**CHICAGO O’HARE INTERNATIONAL AIRPORT
ORDER Up REQUEST FOR PROPOSALS (RFP) FOR “CONCESSION
OPPORTUNITIES IN TERMINALS 1 AND 3”**

Addendum #8 – Answers to Additional Written Questions Opportunity – Full Set

Dated: February 6, 2025

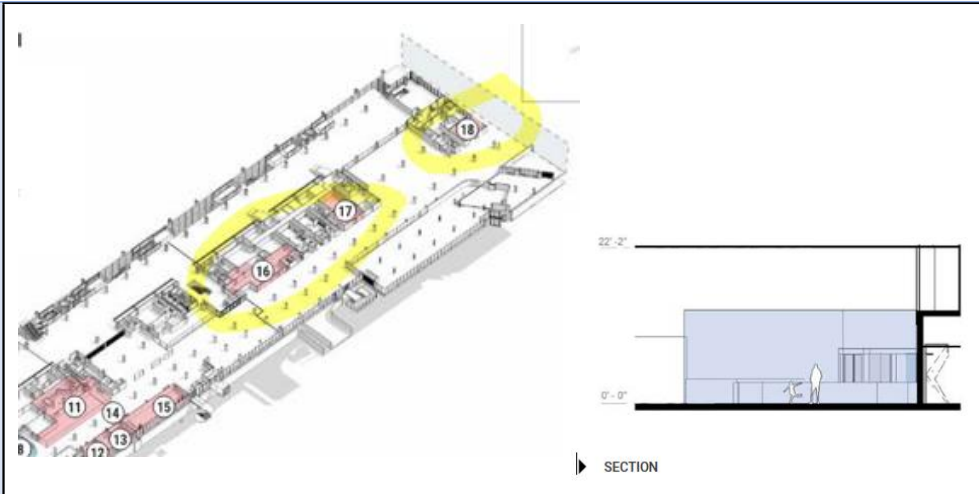
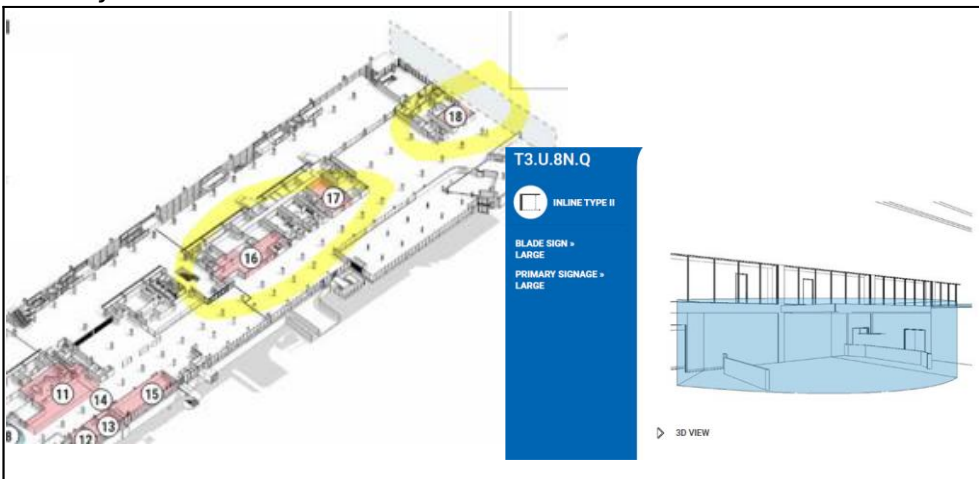
34. **[Related to the Terminal 3 Main Headhouse]** Related to the Terminal 3 Main Headhouse: How tall is the so-called "1-story" construction?

Please see pages 3-161 to 3-166 of the Design Guidelines in the Data room. Once awarded, the CDA will provide issued for construction drawings.

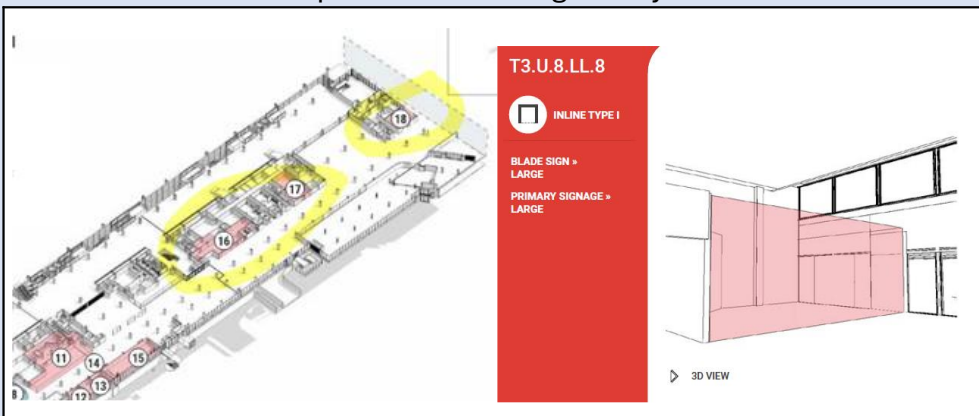
35. **[Related to the Terminal 3 Main Headhouse]** Will the base building construction include a new interior "lid" or deck? Or will it all be open to the existing 2 story terminal?

The locations highlighted in the diagram share a condition where part of the space falls below the existing mezzanine, and rest extends beyond it. The portion below the mezzanine is limited by its height, with no lid. The concession space the extends beyond the mezzanine opens into a two-story space.

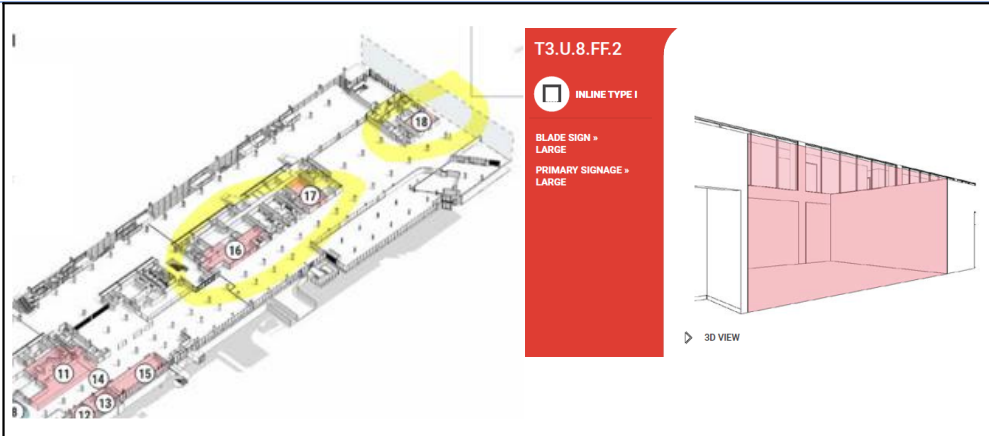
36. **[Related to the Terminal 3 Main Headhouse]** If there is no lid/deck on the expansion spaces how can they be classified as in-line units?* If there is no lid/deck how does a tenant build out a kitchen space that would require a washable ceiling as well as sprinklers?

The locations highlighted in the diagram share a condition where part of the space falls below the existing mezzanine, and rest extends beyond it. The portion below the mezzanine is limited by its height, with no lid. The concession space the extends beyond the mezzanine opens into a two-story space.

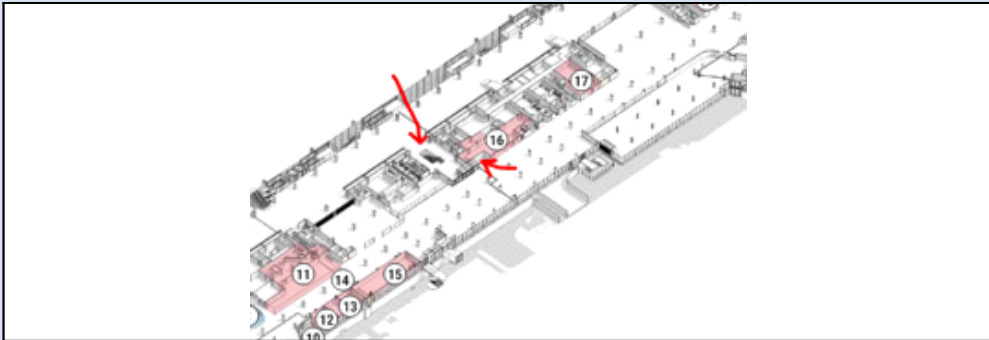
37. [Related to Space ID T3.U.8AA.4] Between column lines Z and AA are there new escalators proposed down to bag claim? Will these replace the existing escalators near columns JJ-KK (east of the existing L Concourse checkpoint)?

Yes, a new escalator will be located between lines 8Y and 8Z.

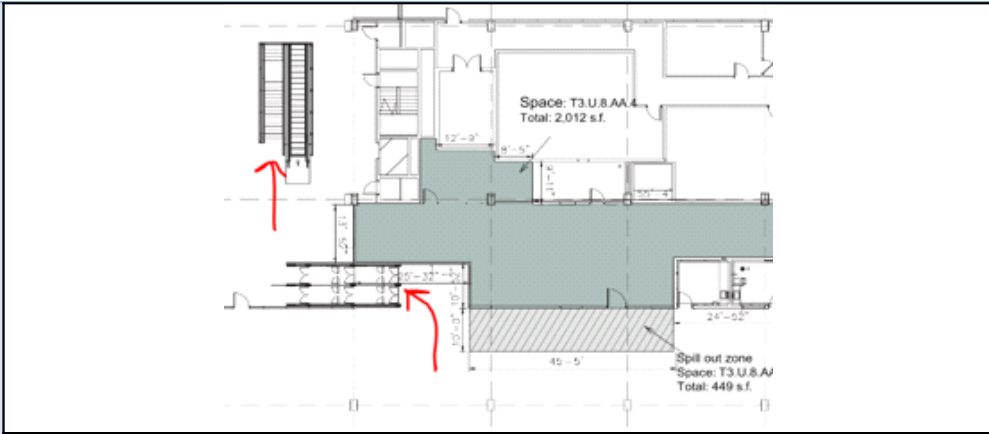
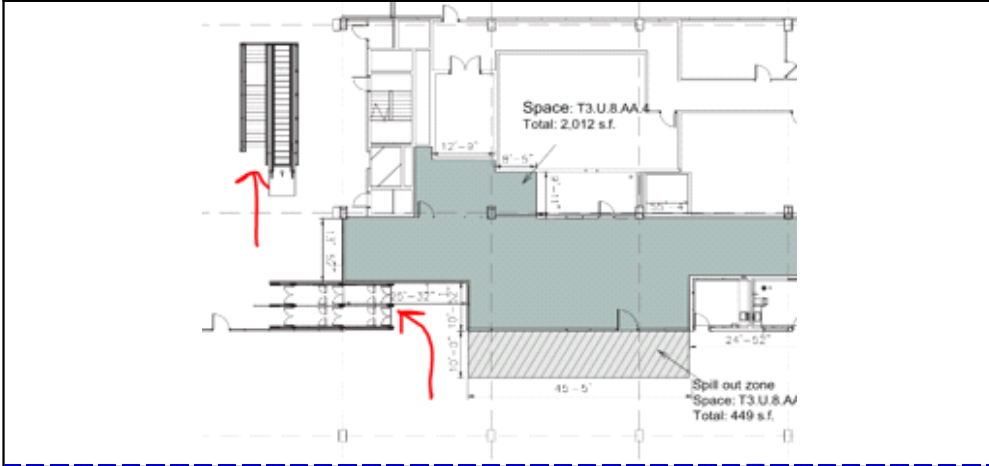
39. [Related to Space ID T3.U.8AA.4] Also, between column lines Z and AA there appear to be new security/exit doors from airside to landside. Will there be any dividers between the tenant space and the pinch point for all the passengers going down to bag claim? (Red arrows)

The exterior walls of T3.U.8AA.4 will serve as primary divider between the concession space and the exit corridor. Once awarded, the CDA will provide issued for construction drawings. The CDA will review all design decisions during the design review process.

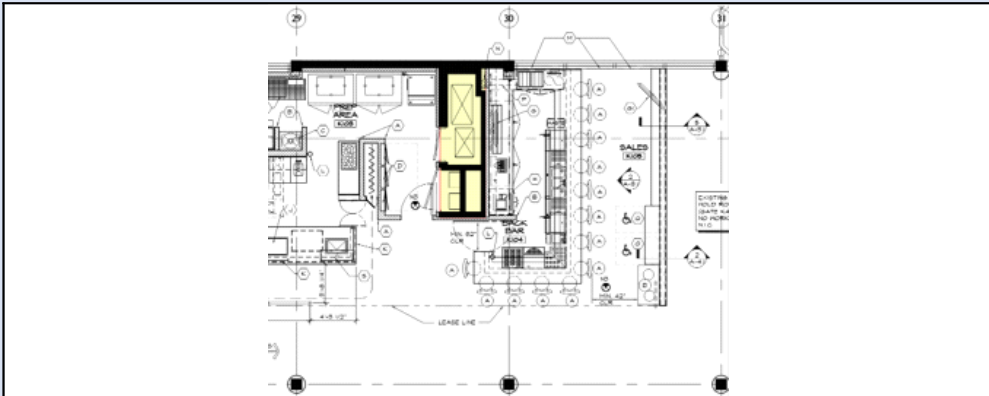
40. [Related to Space ID T3.U.8AA.4] What is the extent of demising walls to be built by others (non concessionaire) in the T3 interior expansion? Various walls or enclosures are depicted in the LOD, but it's unclear what the tenant is responsible to construct.

The CDA will provide a white box with electrical, plumbing and water. Once awarded, the CDA will provide issued for construction drawings for the new spaces. The Architect of Record & Tenant is responsible for verifying any field conditions.

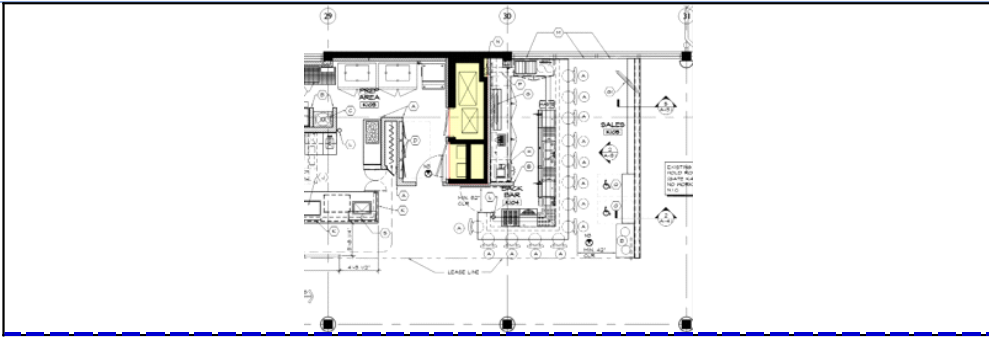
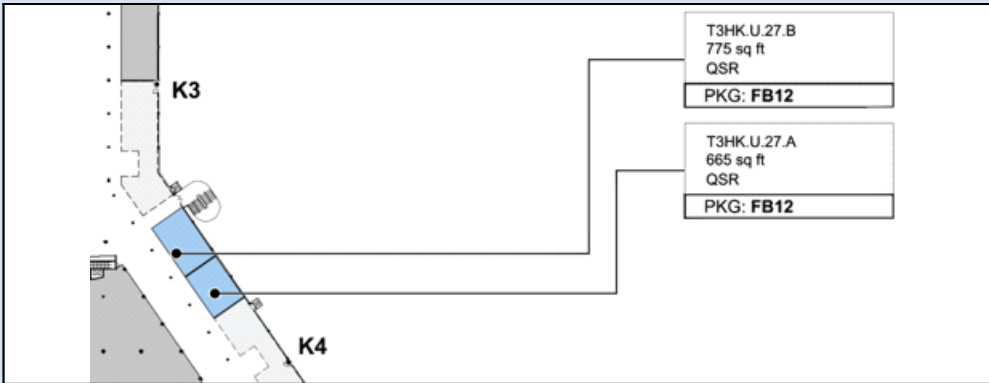
42. [Related to Space ID T3HK.U.27A] Shouldn't bidders know that previous tenant development confirmed that this chase space cannot be moved or altered due to levels served above and below?

Once awarded, the CDA will provide any available requested as-built drawings for the existing spaces. The Architect of Record & Tenant are responsible for verifying any field condition.

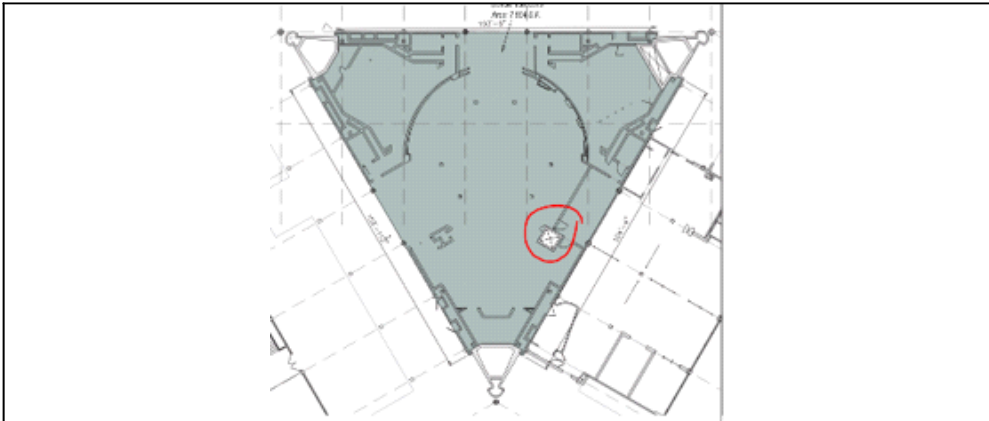
43. [Related to Space IDs T3HK.U.27A and T3HK.U.27B] Since one bidder will 'operate' these 2 units side-by-side, can they maintain the existing single electrical metered service and the single water metered service that would be shared between the 2 'spaces' - assuming the utilities do not require an upgrade? One meter for one operator with 2 concepts, correct?

Each concession must have a separate meter with a separate meter number.

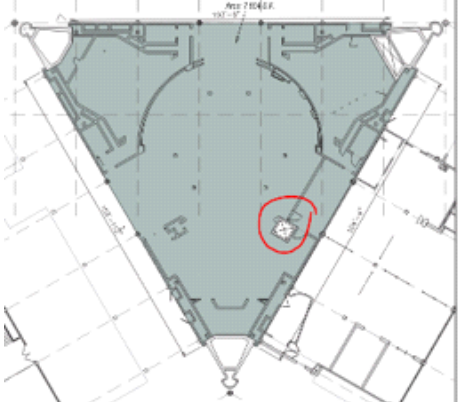
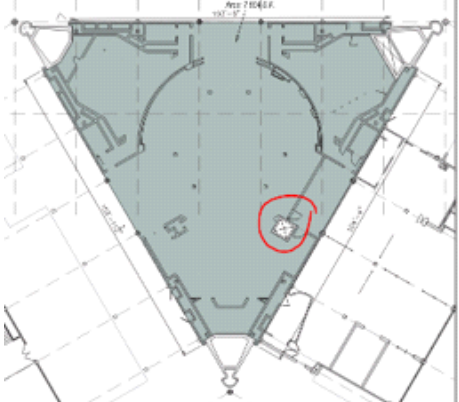
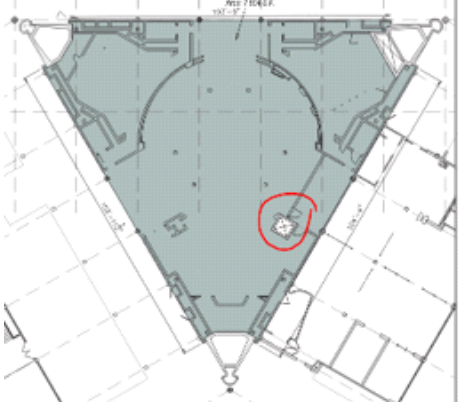
45. [Related to Space ID T3K.U.73] Will the design and construction commencement of this lease area be delayed until the "capital project" has determined the net tenant lease area and configuration?

Once awarded, the CDA will provide a project phasing plan, See ORDER Up! RFP, VI, B, Concession Redevelopment Phasing.

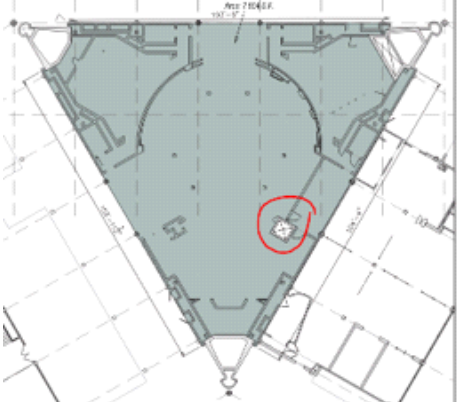
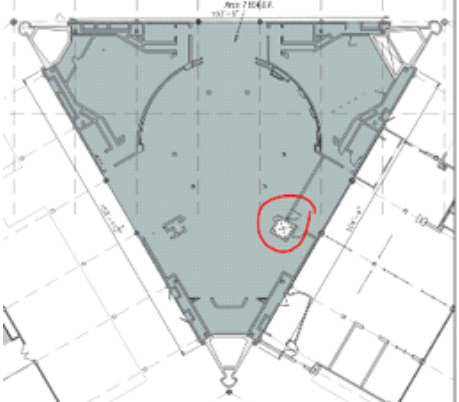
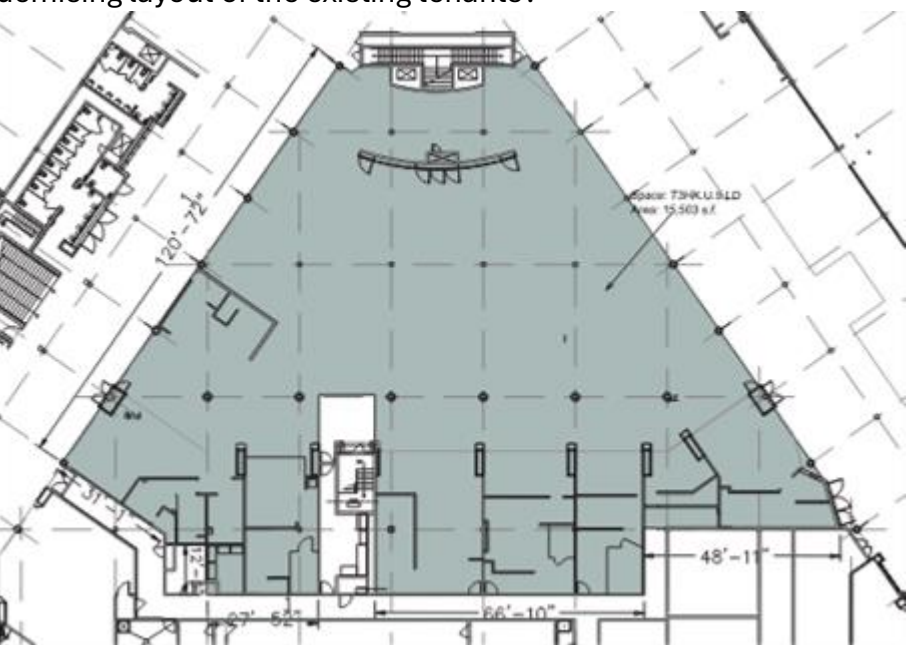
| <p>48.</p> | <p>[Related to Space ID T3K.U.73] The T3 Complete Package Map in the RFP implies that the vacant AA lounge will be removed. Is this true, even if this conflicts with the LOD?</p> | | <p>The vacant AA lounge space is scheduled to be re-programmed as restrooms.</p> |

| <p>49.</p> | <p>[Related to Space ID T3K.U.73] What is the white box (circled) in the LOD plan?</p>  | | <p>The Architect of Record & Tenant will be responsible for verifying any existing elements in the field. The extent of development including demolition may be applied within the boundaries defined by the LOD. Once awarded, the CDA will provide any available requested as-built drawings for the existing spaces.</p> |

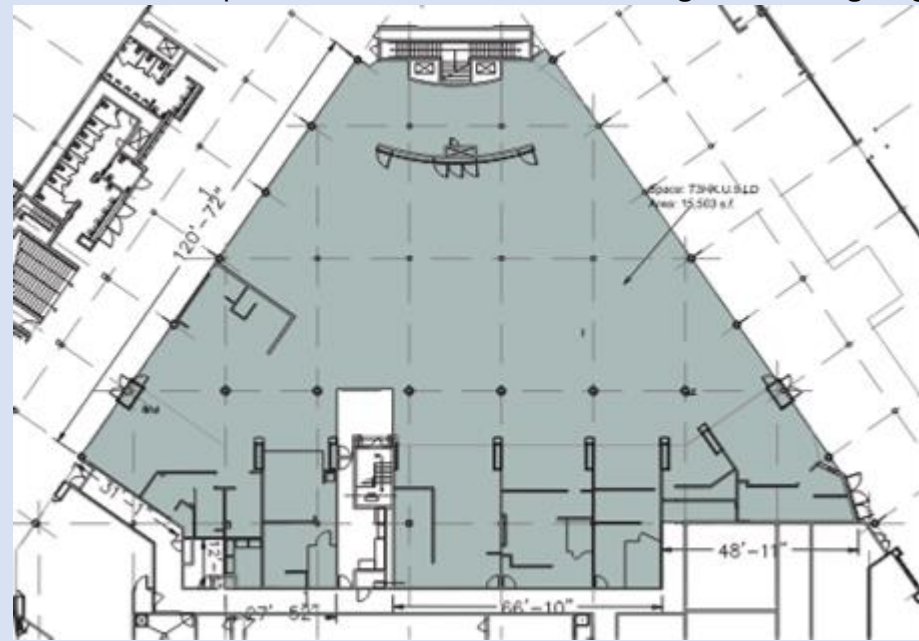
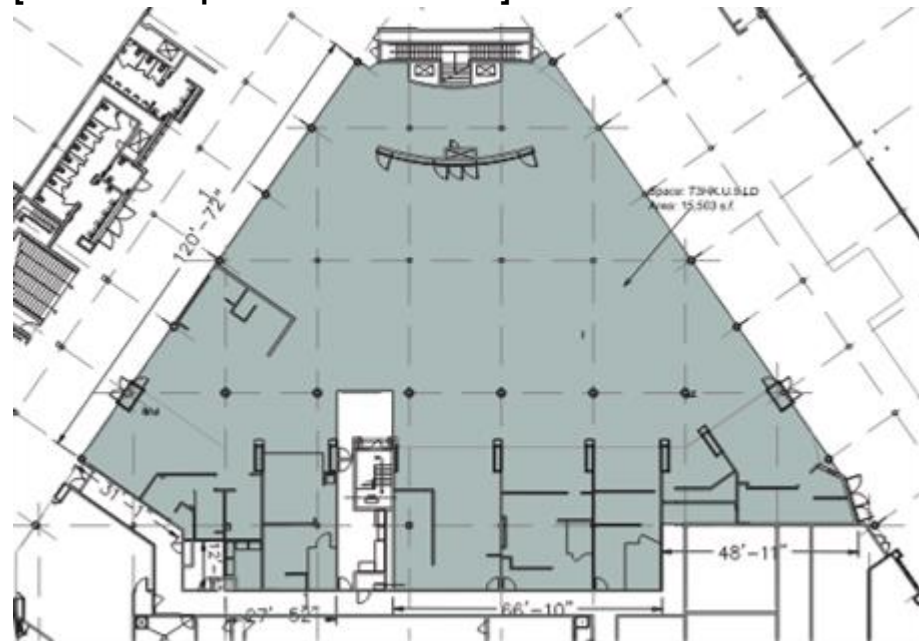
| <p>51.</p> | <p>[Related to Space ID T3HK.U.9L.D] Can the new food court maintain all the base building and tenant HVAC supply and exhaust equipment that was installed in 2000/2001 at the time of the last development?</p> | | <p>The Architect of Record & Tenant will be responsible for verifying any field conditions. Architect of Record & Tenant needs to meet the proposed design</p> |

* Is there an expectation for new terrazzo flooring, new ceiling & lighting throughout the seating area?

Mechanical requirements per the applicable code. The AOR is allowed to design the Tenant space per the O'Hare Concessionaire Design Guidelines | General Design Guidelines, 1-82, HVAC Equipment. Existing equipment should be removed and replaced with new equipment by the new tenant unless otherwise approved by CDA. The CDA will review all design decisions during the design review process.

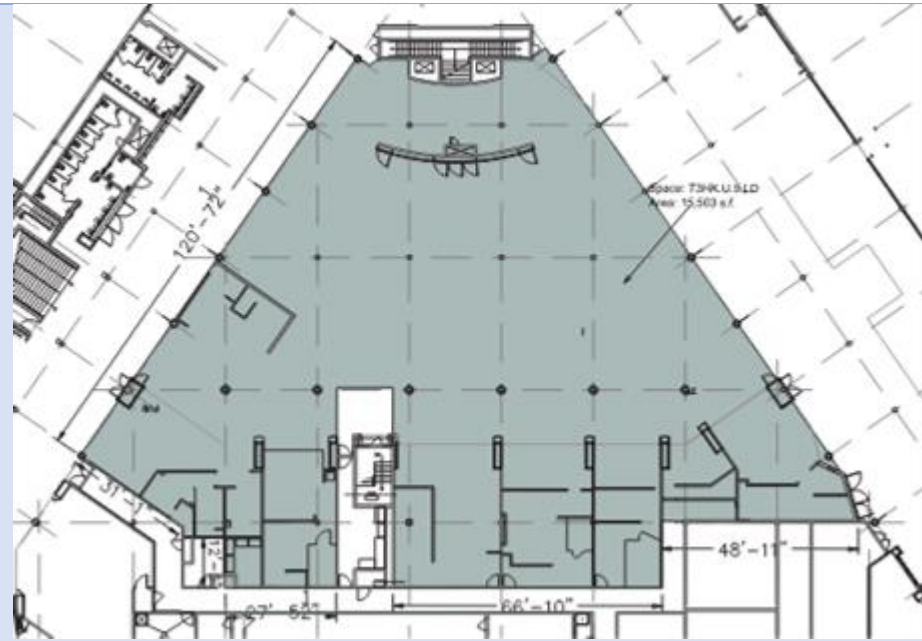
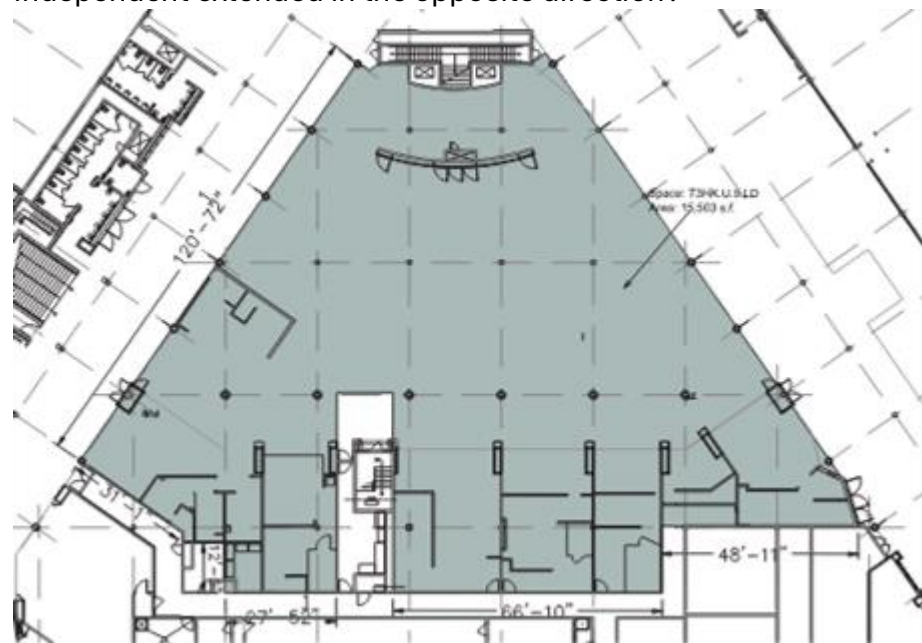
53. [Related to Space ID T3HK.U.9L.D] The existing food court tenants have dry and refrigerated storage in the T3 main headhouse in spaces that will be newly developed in the RFP for new tenant concessions. Where will new storage be located for the new T3 H/K food court tenants?

Remote storage is limited and will be allocated based on availability, tenant occupancy requirements, and leased space.

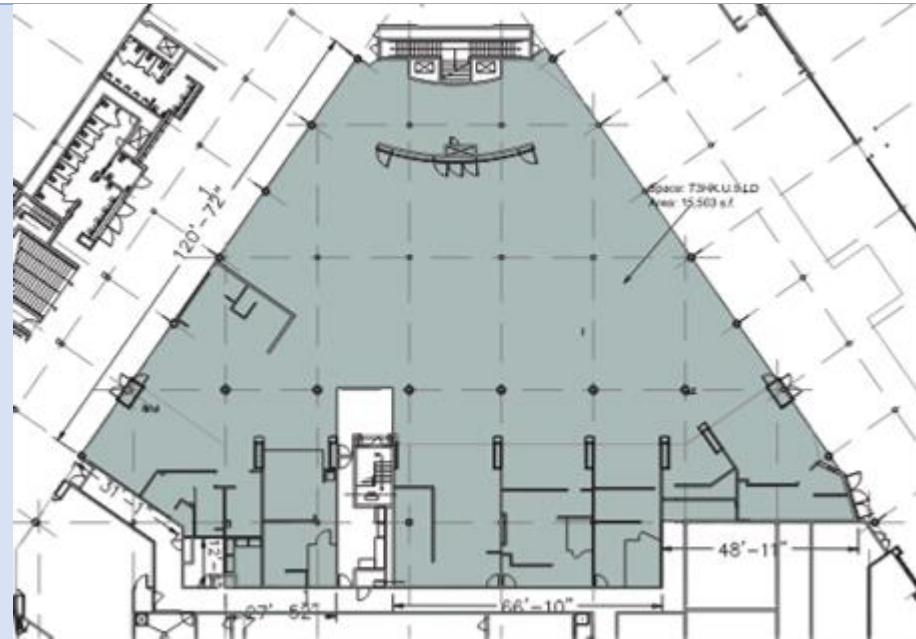
54. [Related to Space ID T3HK.U.9L.D] Will the RFP inform bidders that the existing kitchen exhaust for the former Prairie Tap (now Bronze Tap) is NOT connected to the base building food court exhaust system and is completely independent extended in the opposite direction?

The Architect of Record & Tenant are responsible for the exhaust system design. A load calculation is required to accurately assess whether the proposed concessions have sufficient heating, cooling, or ventilation capacity. The CDA will review all design decisions during the design review process.
